Flight Procedures Cover Page	Task Action: FLIGHT CHECK	Task Type: IAP	Estimated Chart Date: 12/02/2021	APWS Task ID: 8590E5DADFF84817BEBEC83D64D4C5D1	APWS Project ID: 580D64EF060040CBA9D5ECD5FB73615EF
Procedure: RNAV (GPS) RWY 4RAMDT 1		Enroute: NO	Specialist: Lindholm, Scott		Agreement Number:
Airport ID: KCHD			Airport City: CHANDLER		State: AZ
Facility ID:	Facility Type:	Flight Inspection Remark Type: New FC Slot

<b>FIPC BASIC FORM</b>							
<b>PROCEDURE:</b> RNAV (GPS) RWY 4RAMDT 1			<b>AIRPORT NAME:</b> CHANDLER MUNI		<b>AIRPORT ID:</b> KCHD	<b>SPECIAL CONTROL NO:</b> SG-08-104-21	
<b>FAC ID:</b> KCHD04R.01		<b>CITY:</b> CHANDLER			<b>ST:</b> AZ	<b>ORIG CHART DATE:</b> 12/02/2021	
<b>DFL TYPE:</b> PROC/S	<b>THIRD PARTY:</b> <input type="checkbox"/> YES	<b>EST. TIME ON SITE:</b> 0.4	<b>REIMB. NUMBER:</b>		<b>PTS TASK ID:</b>		
<b>PREFLIGHT NOTES</b>							
<b>REVIEWER:</b>					<b>DATE:</b>		
<b>COMMENTS:</b>					<b>CHECK ONE:</b>		
					<input type="checkbox"/> FLT CK REQ <input type="checkbox"/> NFCR <input type="checkbox"/> REJECT		
							<b>YES</b>
					<b>CPV COMPLETE?</b>		<b>X</b>
<b>PROCEDURE RESULTS</b>							
<b>INSPECTION DATE:</b> 10/07/2021		<b>CREW #:</b> VN235

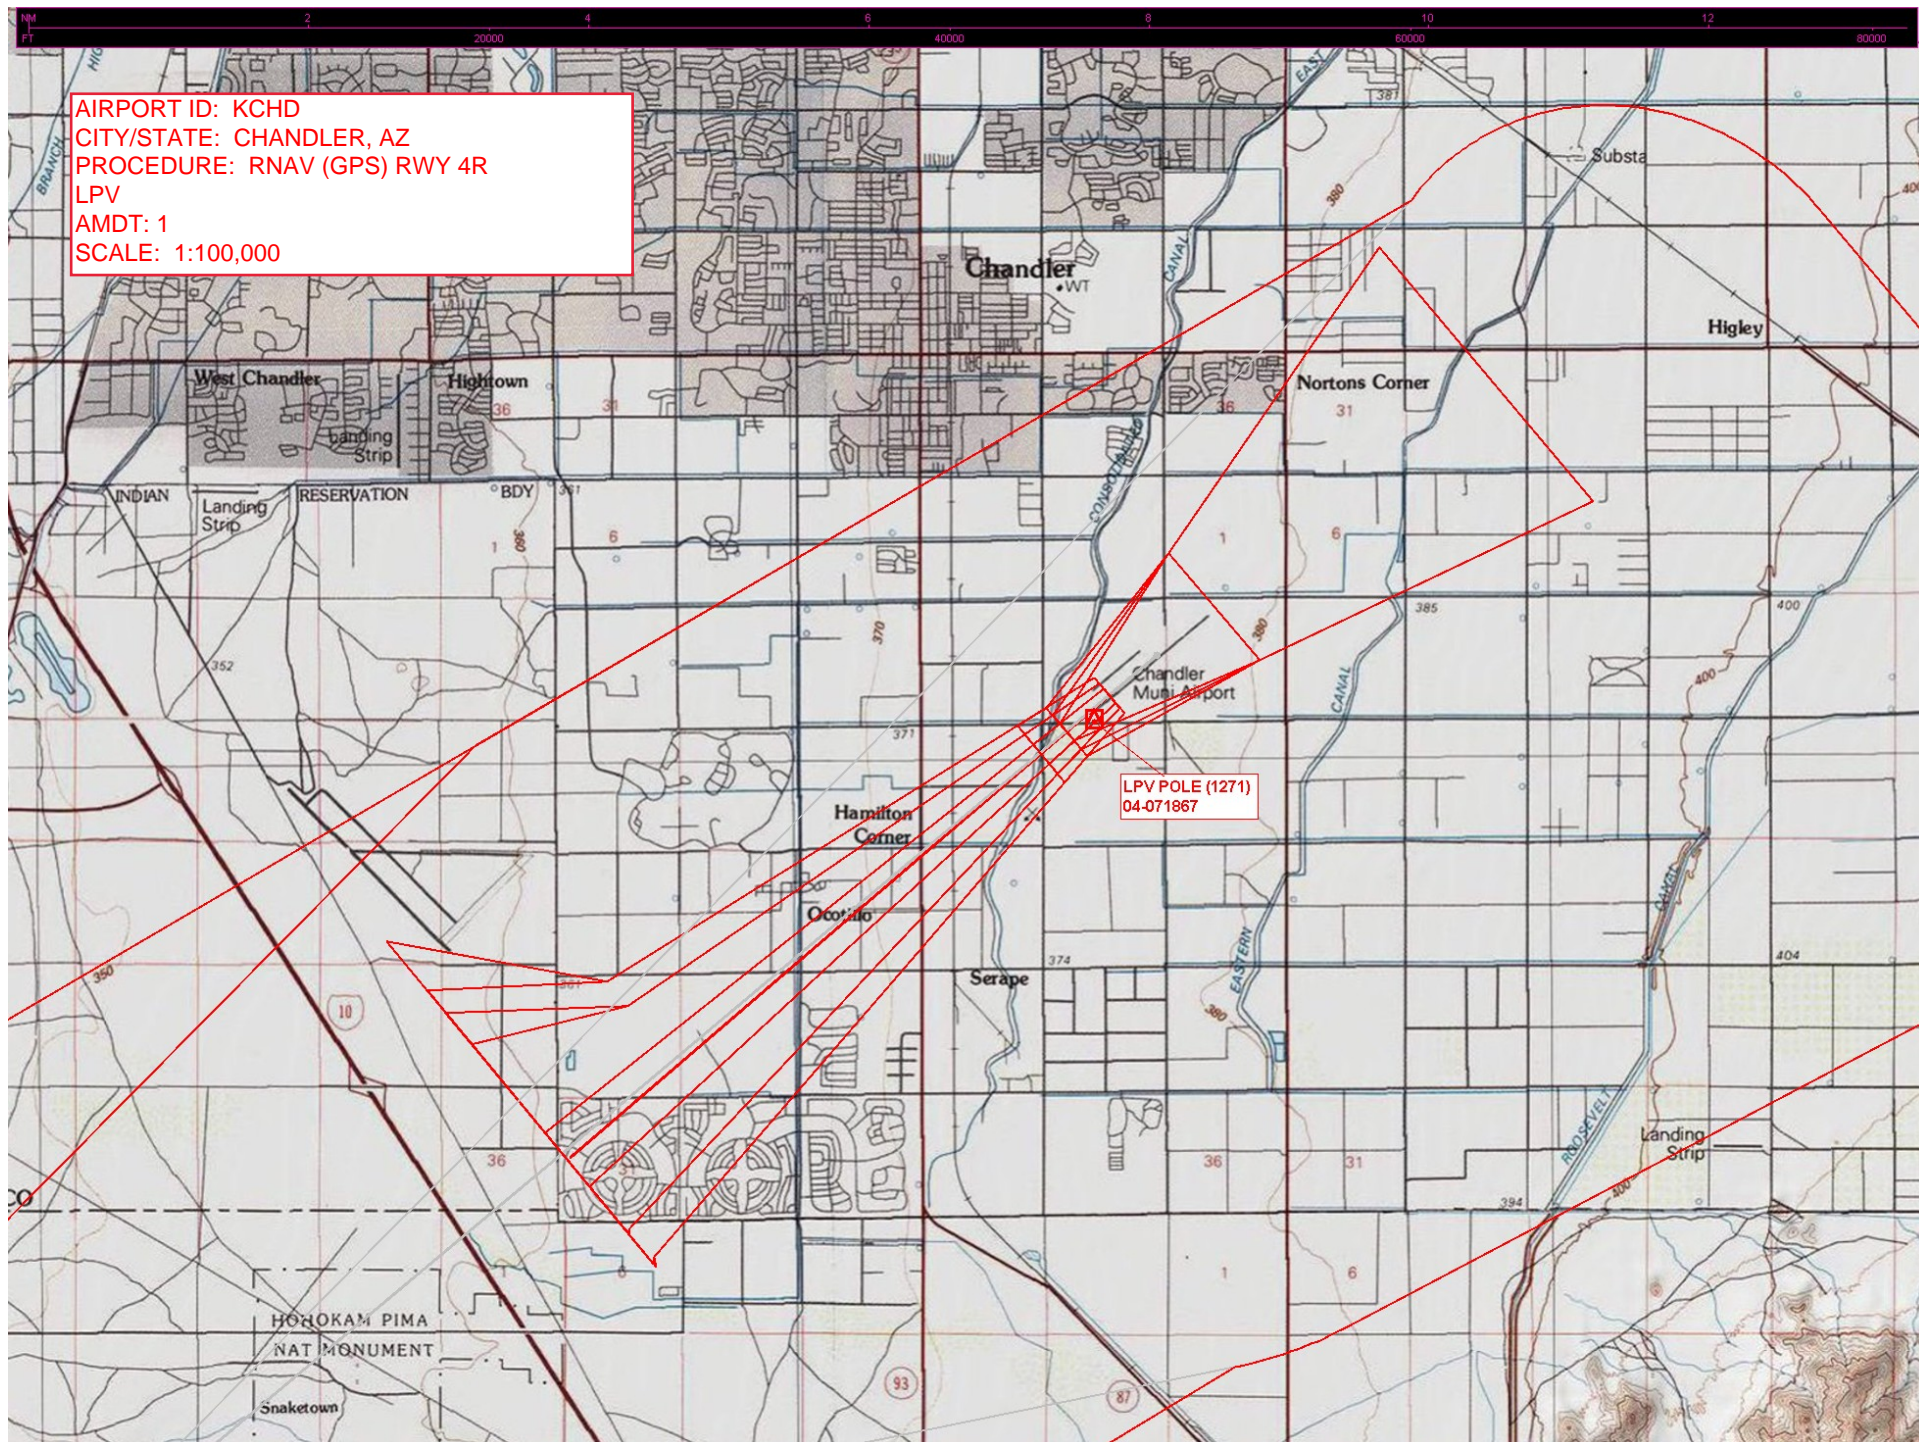
FULL AMENDMENT TO ADD LPV AND LNAV/VNAV MINIMA.

1. REMOVED CHART PLANVIEW NOTES: PROCEDURE NA FOR ARRIVALS AT PXR VORTAC ON V528 SOUTHWEST BOUND AND PROCEDURE NA FOR ARRIVAL ON PXR VORTAC AIRWAY RADIALS 143 CW 260.

2. ADDED CHART PLANVIEW NOTE: PROCEDURE NA FOR ARRIVALS AT PXR VORTAC ON V16 AND T306 EASTBOUND.

**Figure 1. Proposed Amendments to RNAV (GPS) RWY 04R**

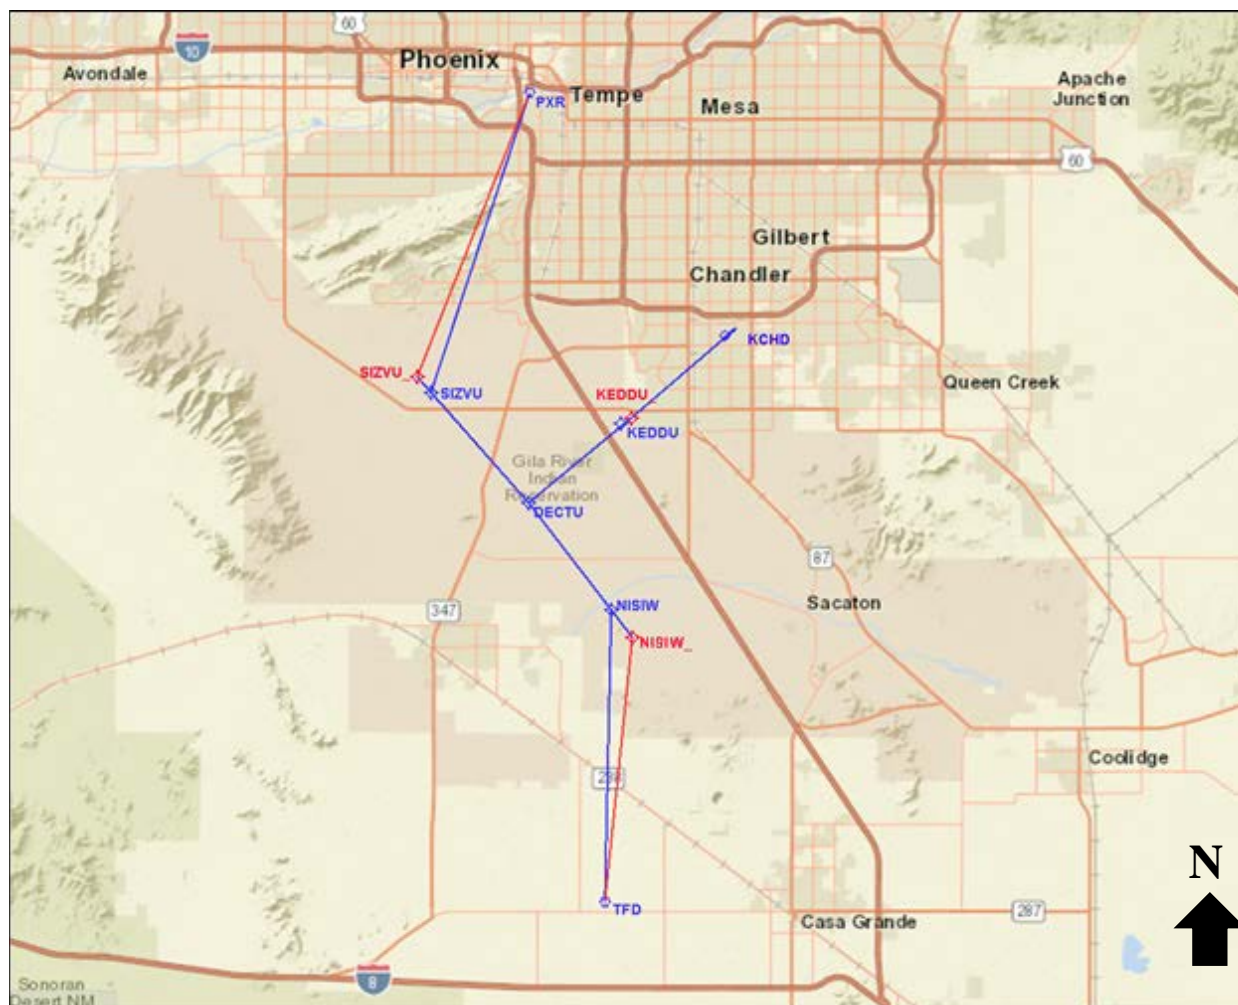
Procedure	Proposed Amendments
RNAV (GPS) RWY 04R	<ul style="list-style-type: none"> <li>• SIZVU initial approach fix (IAF) would move approximately (~) 0.86 nautical miles (NM) northwest to comply with existing criteria. The feeder segment from Phoenix (PXR) very high frequency omnidirectional range and tactical air navigation system (VORTAC) to SIZVU IAF would change course from 186 degrees (°) to 190°. The lateral shift would be ~5,200 feet (ft) west of the existing segment track.</li> <li>• NISIW IAF would move ~1.42 NM southwest to comply with existing criteria. The feeder segment from Stanfield (TFD) VORTAC to NISIW IAF would change course from 349° to 354°. The lateral shift would be ~5,450 ft east of the existing segment track.</li> <li>• The glide path and threshold crossing height (TCH) would be updated from 2.90° and TCH 37 ft above ground level (AGL) to 3.16° and TCH 40 ft AGL, which would match the visual glide slope indicator and avoid vertical guidance surface penetrations. This would move KEDDU precision final approach fix (PFAF) ~0.46 NM closer to RWY 04R at the same altitude (at or above 2,900 ft mean sea level [MSL]).</li> <li>• The final approach course from KEDDU PFAF to the RWY 04R threshold would update from 039° magnetic north to 038° magnetic north from DECTU intermediate fix (IF)/IAF. Localizer performance with vertical guidance (LPV) and lateral navigation (LNAV)/vertical navigation (VNAV) minimums would be added. The height above touchdown (HAT) for LPV would be 250 ft AGL, and the HAT for LNAV/VNAV would be 452 ft AGL. The LNAV minimum descent altitude (MDA) would increase by 20 ft.</li> <li>• Circling would adhere to the newest circling criteria. The circling MDA would increase ~40 ft.</li> <li>• Missed approach instructions would read: “Climb to 2,200 ft MSL then climbing right turn to 4,000 ft MSL direct DECTU IAF. A 210-knot speed restriction would be added to the missed approach for obstacle avoidance.”</li> </ul>
